Subject: License Amendment Application to Increase Allowable Power  
(License Amendment Request No. 00-0006)

Enclosed is an application for an amendment to the Davis-Besse Nuclear Power Station (DBNPS), Unit Number 1 Operating License Number NPF-3, including the Appendix A, Technical Specifications. The proposed changes involve: Operating License (OL) paragraph 2.C(1), Maximum Power Level; OL paragraph 2.C(3)(d), Additional Conditions; Technical Specification (TS) 1.3, Definitions – Rated Thermal Power; TS 2.1.1, Safety Limits – Reactor Core, and associated Bases; TS 2.2.1, Limiting Safety System Settings – Reactor Protection System Setpoints, and associated Bases; TS 3/4.1.1.3, Reactivity Control Systems – Moderator Temperature Coefficient; TS 3/4.2.5, Power Distribution Limits – DNB Parameters; TS 3/4.4.9.1, Reactor Coolant System – Pressure/Temperature Limits, and associated Bases; and TS 6.9.1.7, Core Operating Limits Report.

Proposed Modifications to the Davis-Besse Nuclear Power Station (DBNPS) Unit Number 1, Facility Operating License NPF-3, Including the Appendix A Technical Specifications, to Allow a Power Uprate and to Revise Departure From Nucleate Boiling Parameters.

Figure 2.1-1 Reactor Core Safety Limit

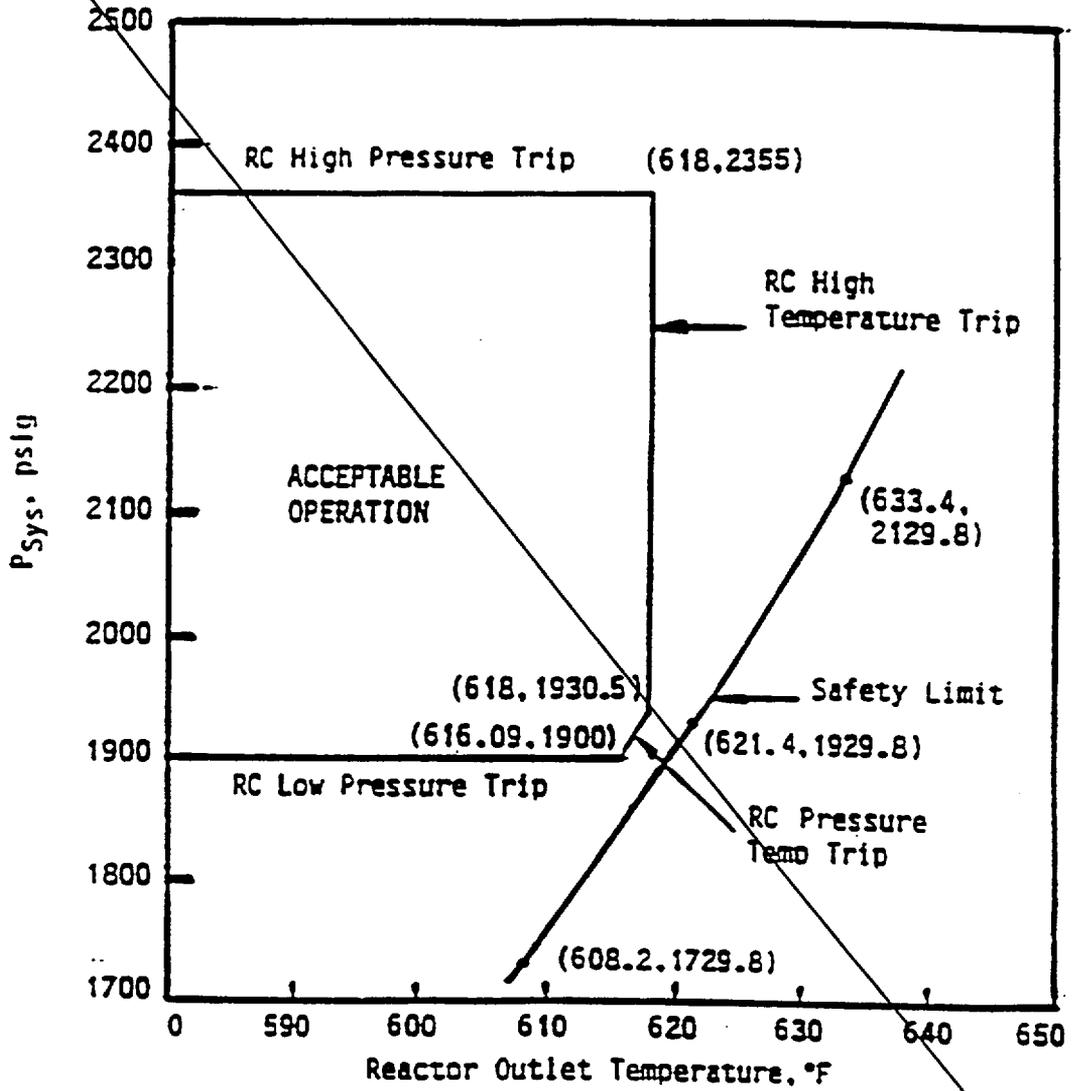
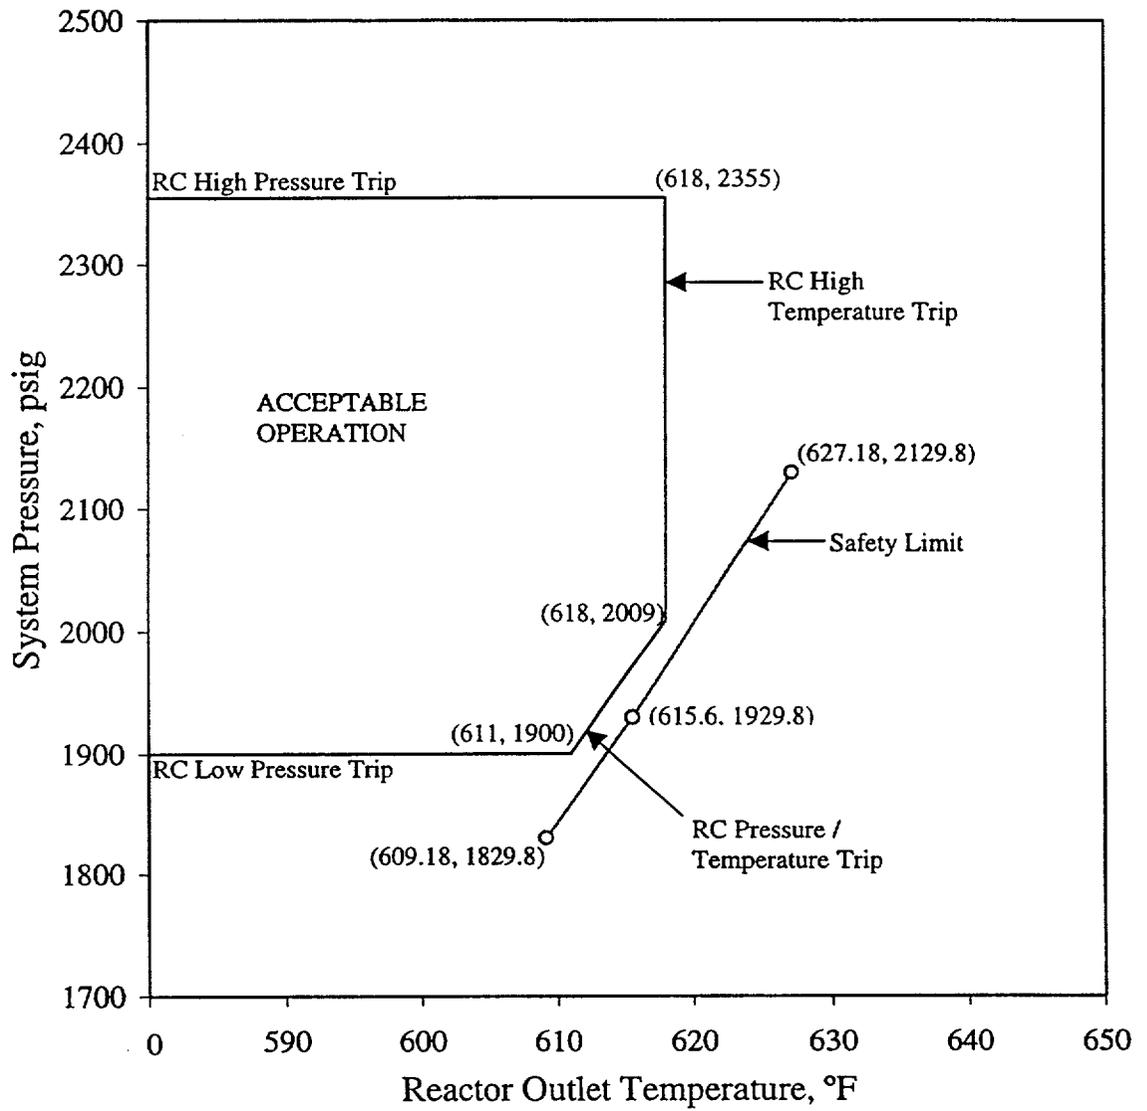
TS 2.1.1 states that the combination of reactor coolant outlet pressure and outlet temperature shall not exceed the safety limit shown in Figure 2.1-1, Reactor Core Safety Limit. It is proposed to revise Figure 2.1-1 to reflect updated data as a result of the proposed power uprate. Related changes to the associated TS Bases are also proposed, including a revised Bases Figure 2.1, Pressure/Temperature Limits at Maximum Allowable Power for Minimum DNBR.

The proposed revision to TS Figure 2.1-1 is in accordance with updated analyses in support of the proposed power uprate, as described in Reference 3. These analyses showed that more restrictive reactor core safety limits were appropriate. Based on the Reference 3 evaluation, this proposed change will have no adverse effect on nuclear safety.

Replace with  
new figure  
(next page)

The curve presented in Figure 2.1-1 represents the conditions at which a minimum DNBR equal to or greater than the correlation limit is predicted for the maximum possible thermal power of 110.2% of 2817 MWt ±12% when the reactor coolant flow is 380,000 GPM, which is approximately 108% of design flow rate for four operating reactor coolant pumps. (The minimum required measured flow is 389,500 GPM). This curve is based on the design hot channel factors with potential fuel densification and fuel rod bowing effects.

Bases Figure 2.1 Pressure/Temperature Limits at Maximum Allowable Power for Minimum DNBR

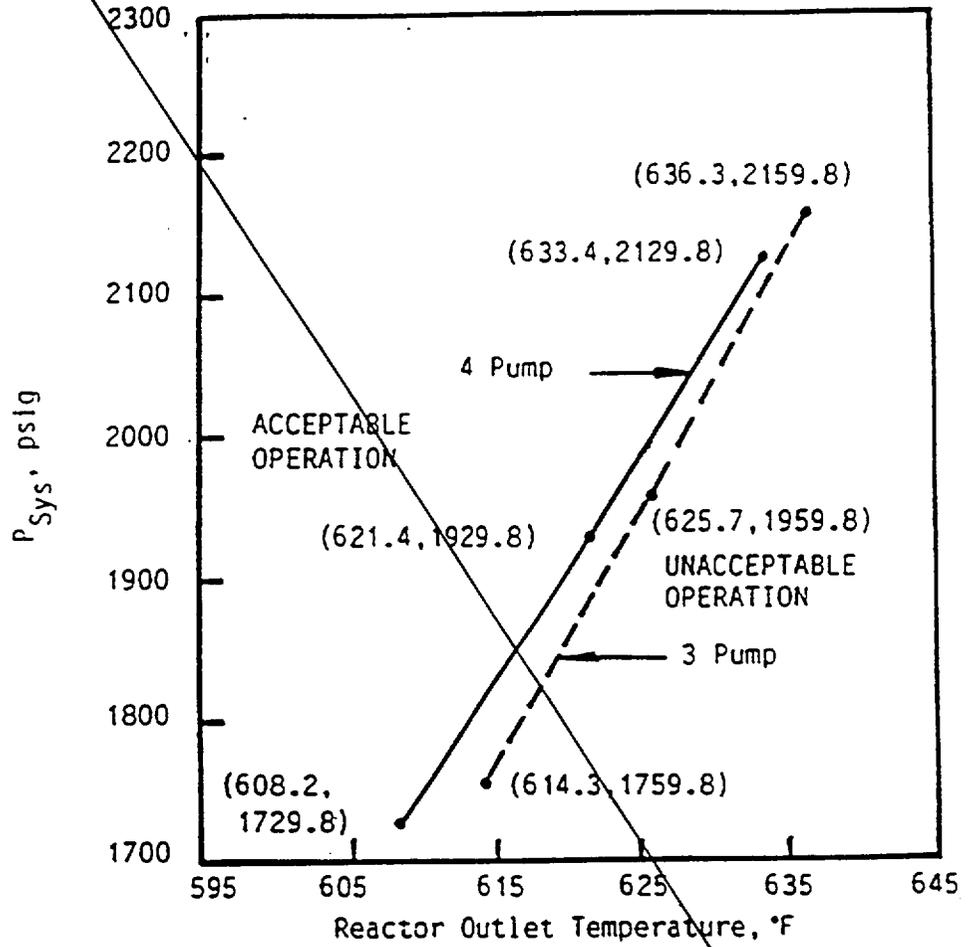
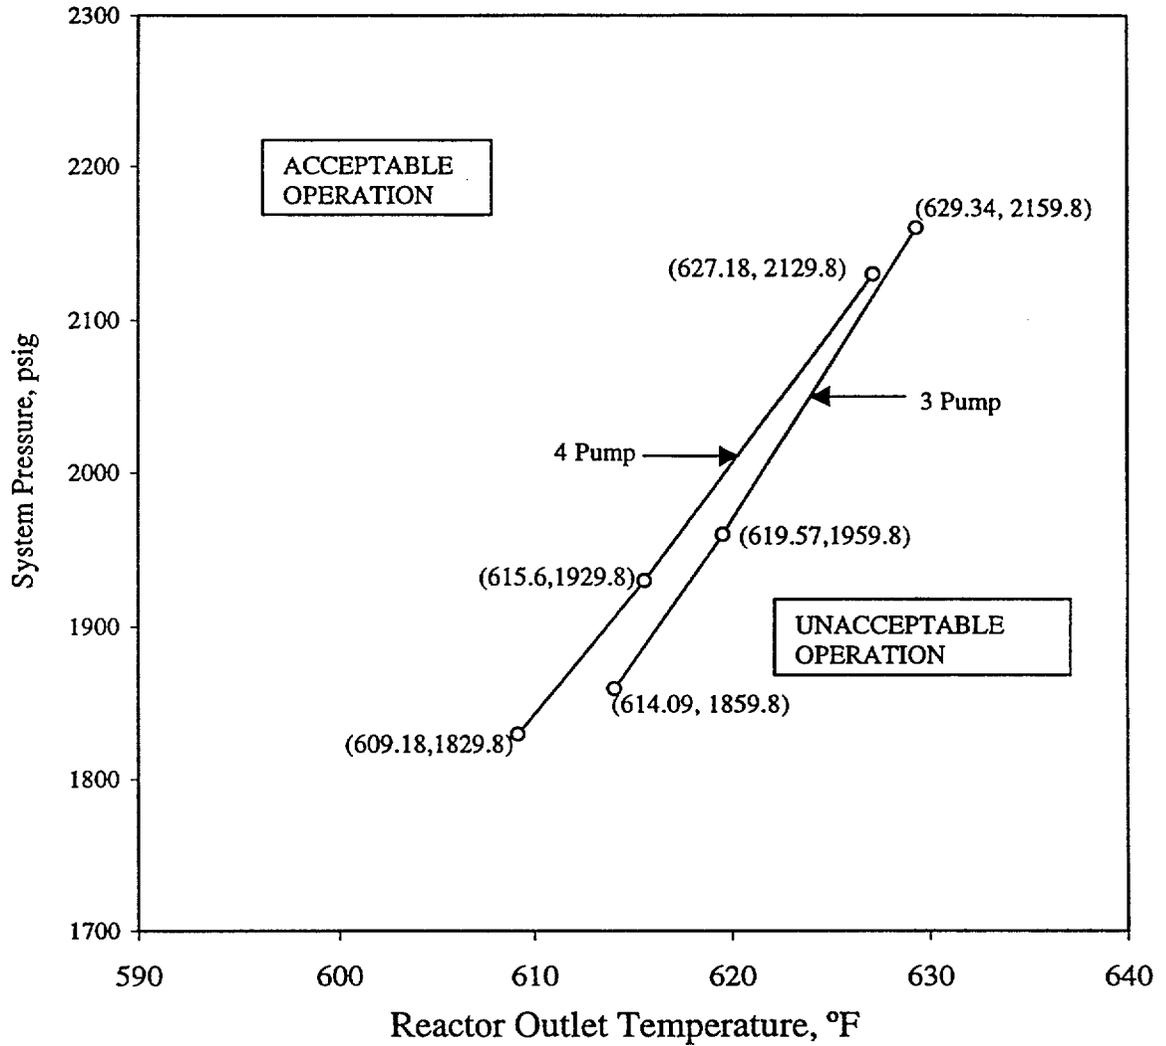
The proposed changes to the associated TS Bases, including a revised Bases Figure 2.1 are related to the above changes, and, as such, are administrative changes that will have no adverse effect on nuclear safety. These changes are supported by the reviews and evaluations described in Reference 3, and reflect the use of the Framatome ANP evaluation method for Statistical Core Design, BAW-10187P-A (Reference 8), that is the basis for the power uprate program DNBR safety evaluations.

*Replace with new Figure (next page)*

<u>Pumps</u>	<u>Flow, gpm</u>	<u>Power</u>	<u>Required Measured Flow to ensure Compliance, gpm</u>
4	380,000	110.2 %	389,500
3	283,860	89 %	290,957

Reactor Coolant System Pressure-Temperature Limits  
For Heatup and Core Criticality for the First ~~20~~ 21 EFY

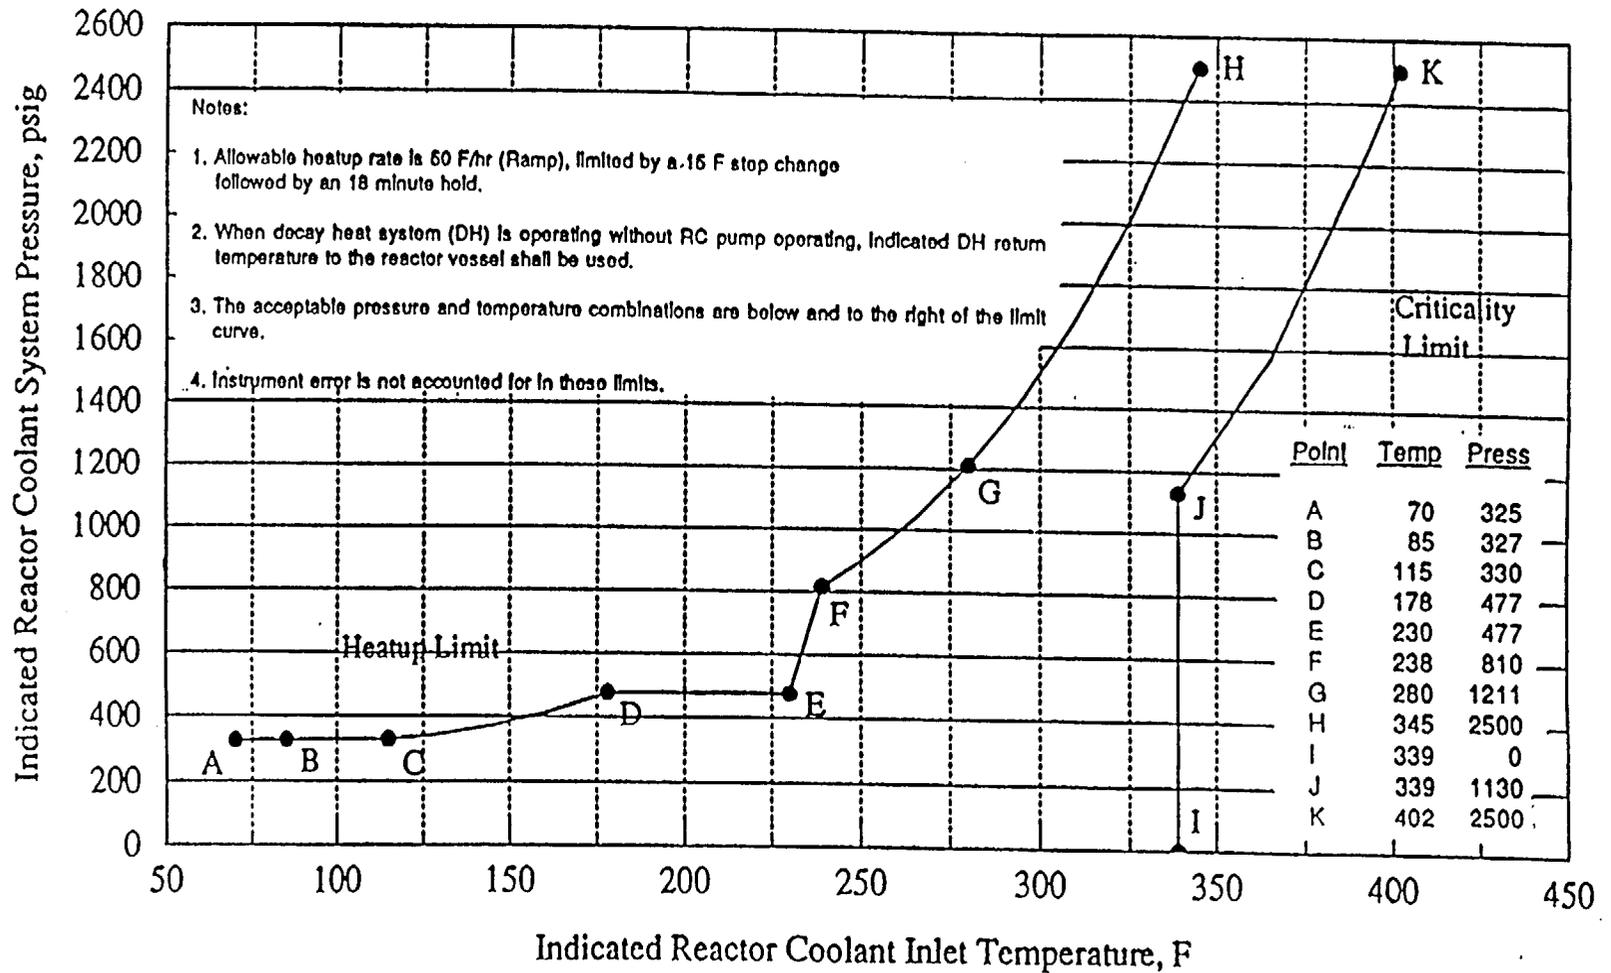
The titles of TS Figures 3.4-2, 3.4-3, and 3.4-4 presently state that they apply for the first 21 Effective Full Power Years (EFPY) of operation. As a result of the proposed power uprate, it is proposed to revise the titles to reflect that these figures now apply to the first 20 EFPY of operation.

The proposed revisions to the titles of TS Figures 3.4-2, 3.4-3, and 3.4-4 is in accordance with updated analyses in support of the proposed power uprate, as described in Reference 3. These analyses showed that due to the power uprate, the pressure/temperature limit curves shown in the figures are now only applicable to the first 20 Effective Full Power Years (EFPY) of operation, rather than the current 21 EFPY. This change continues to ensure that the Reactor Coolant System pressure/temperature limits will be appropriately maintained and, accordingly, this change will have no adverse effect on nuclear safety.
